RE-DISCHARGE REQUIREMENT 6 ENGINEERING & DESIGN - GANTRIES & CCTV CHANGES

PREPARED FOR DCO RE-DISCHARGE PURPOSE	
Project	SMART MOTORWAYS PROGRAMME
Drawn By	M4 Junctions 3-12
Checked By	William Emery
Scale	1:1250
Date	18/02/2022
Project No.	H4514651
Version	1.0
Author	CHU
Project No.	H4514651
Version	1.0
Author	CHU
Project No.	H4514651
Version	1.0
Author	CHU

Sheet 53 of 60

Ch 16400.000 - 15500.000

H4514651-CHU-H4514651_ML_ZZZZZZZZ_2-DR-CH-1083

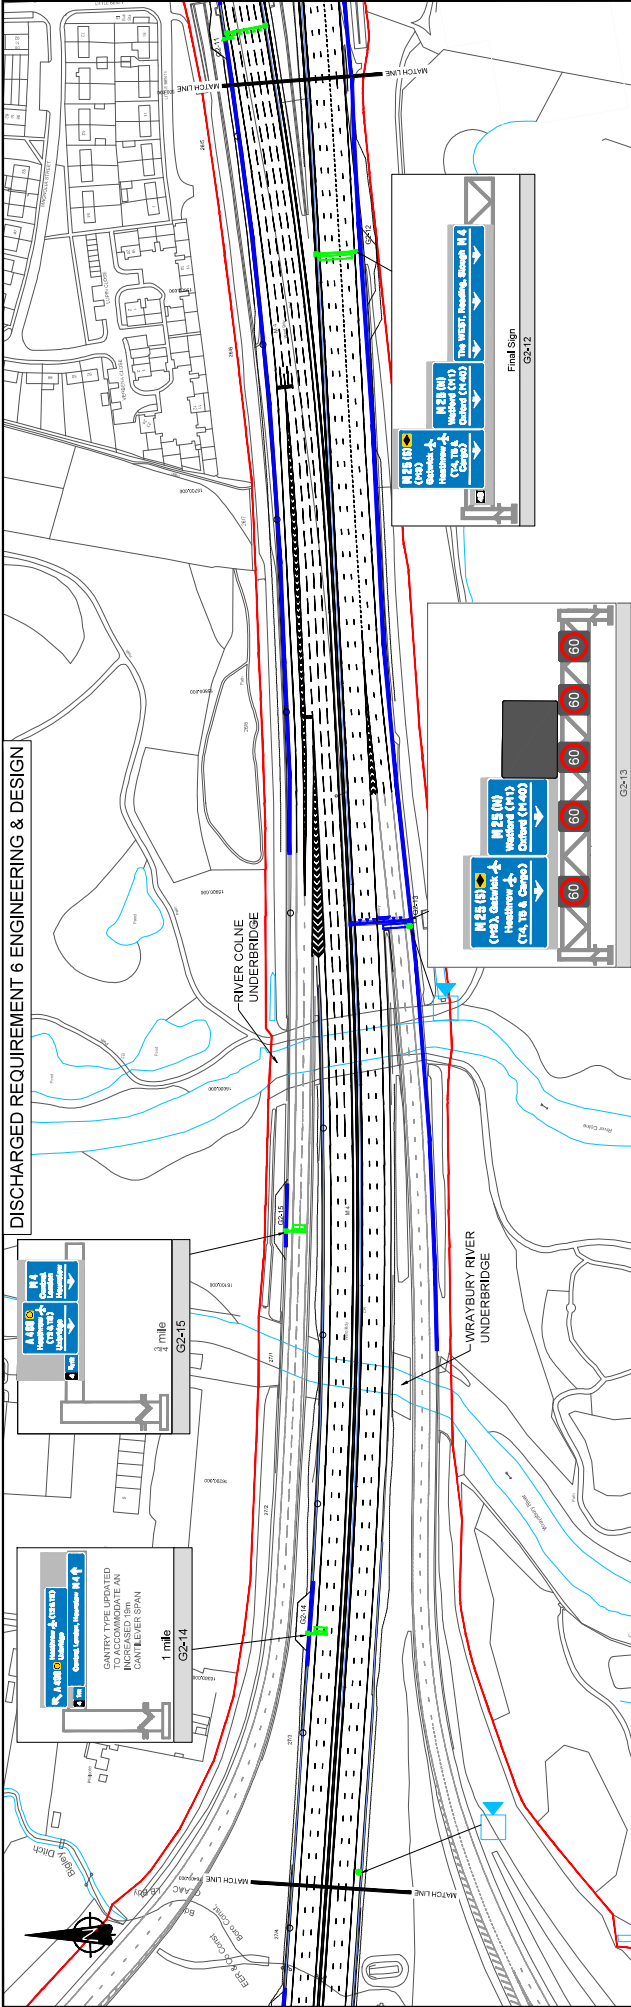
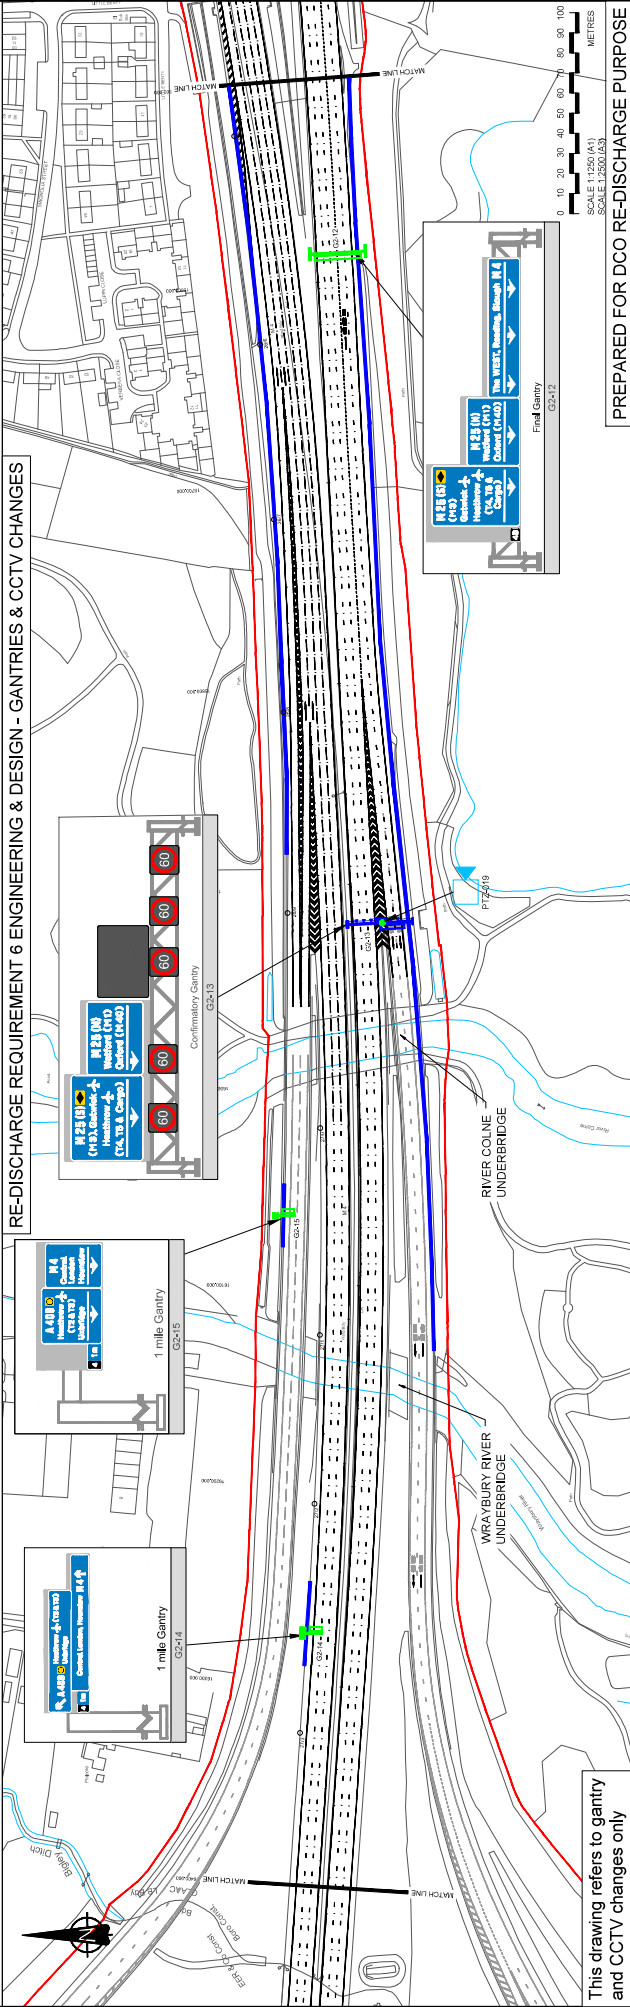
This drawing refers to gantry and CCTV changes only
